Support Bulletin-SB-25-10045

Title: O-Ring Missing Between PWM Valve Block & Hydraulic Motor

Model: 164-FTA1609

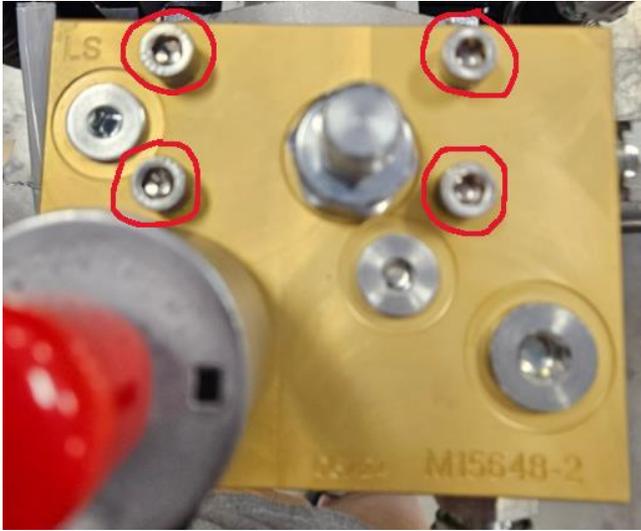
Overview: A batch of 164-FTA1609 PWM Valve/Motor assemblies were assembled incorrectly from the vendor and are missing either 1 or both o-rings that sit in between the PWM block and hydraulic motor. With 1 or both o-rings missing the assembly will leak hydraulic oil from between the two pieces.

Each motor requires two o-rings. SurePoint will warranty two o-rings and overnight ship them to the customer. These o-rings are a standard size that can also be sourced locally if the customer prefers. The SurePoint part number and description is:

166-ORING-112 (112 Buna 70 Duro O-Ring, Between Eaton Motor & Hydraulic Block (2 per motor))

Remove the 4 circled bolts with a ¼" allen wrench
Separate PWM valve block from motor and install two new o-rings
Reattach PWM valve to motor and reinstall the four bolts.
